OUTER GREEN BELT MANAGEMENT PLAN HEARING SUBCOMMITTEE

MINUTE ITEM ATTACHMENTS

Outer Green Belt Management Plan 2019

Submission specific to the inclusion of the Mountain Bike Tracks on Johnston Hill.

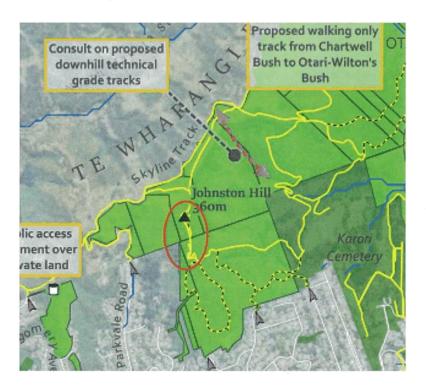
On Page 140 of the Plan it correctly states; "Tracks in Ōtari Wilton's Bush and on Johnston Hill have been designated walking-only under the Open Space Access Plan 2016 as being unsuitable for biking."

The Sector 4 Map on page 146 incorrectly notes the upper part of the Penlington Track on the ridgeline has been denoted as a "Shared Use Track". This has previously never been the case as Johnston Hill signage has always had a "No Cycling" sign included. The upper part of this track on the ridge is primarily stairs and is unsuited for cycling.

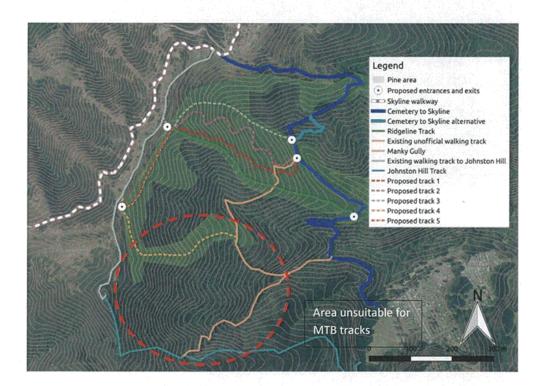
As such, I submit that the use of the Johnston Hill track for uphill cycling, and tracks 4 and 5 as located are unsuitable for mountain bike tracks they will affect the ecology and potential for bush regeneration.

Should the consideration for a mountain bike area be included in the Management Plan, I would submit that it should be qualified with an appropriate area rather than a general description open to interpretation.
